November 20, 2018

**Subject: Response to EPA and Stakeholder Comments
Confirmation Borings in Former Process Area
Former Koppers Wood Treating Site
Gainesville, FL**

Figure 1. DNAPL recovery for wells post-ISGS spot treatment.(03/29/17-10/23/18)

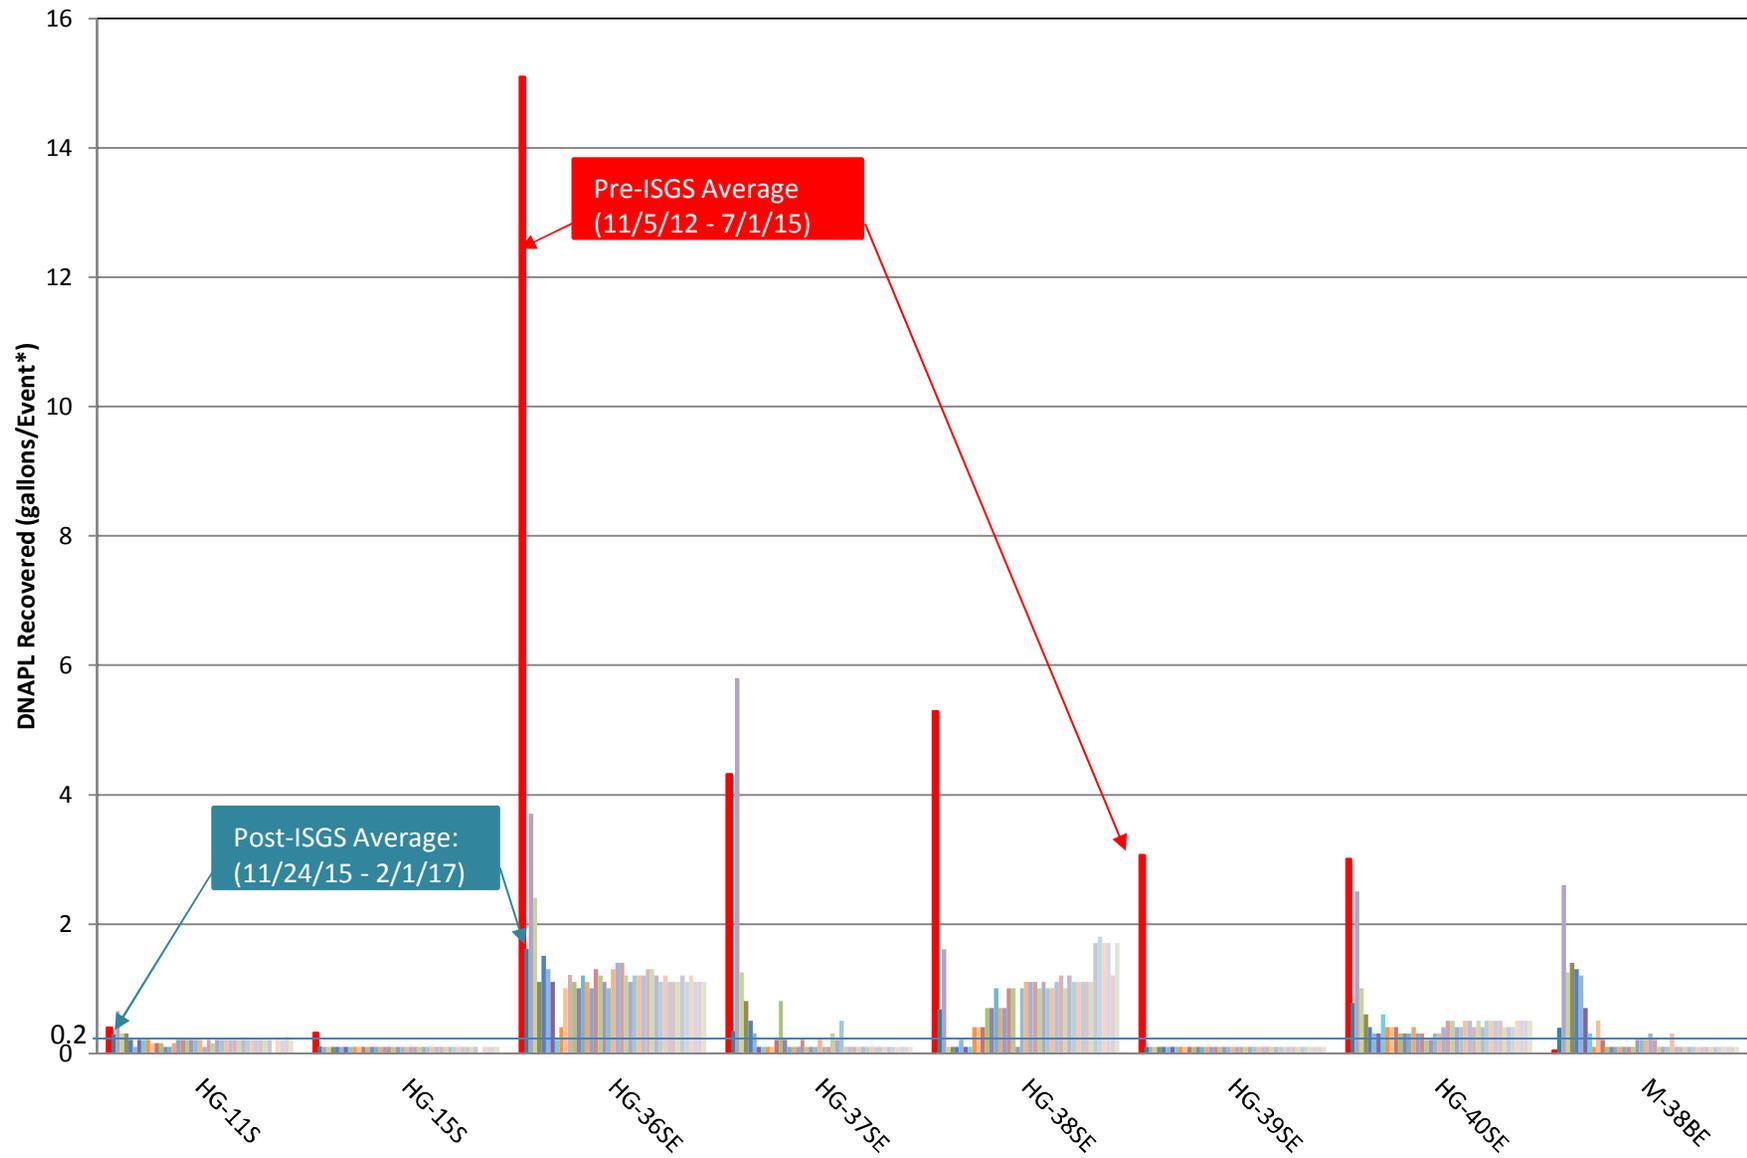
Comment #3: *“Black & Veatch also requests that any recent DNAPL recovery information from the Process Area be provided for review.”*

Response: Beazer provided the EPA/Stakeholders with DNAPL recovery graphs for each of the TIPs and wells via an email dated June 8, 2018, as requested in this comment. In addition, tabulated DNAPL recovery data in Excel spreadsheets were provided to the EPA/Stakeholders via an email on June 12, 2018. Updated DNAPL recovery graphs (Figures 1, 2 and 3) through October 2018 are provided with this response letter.
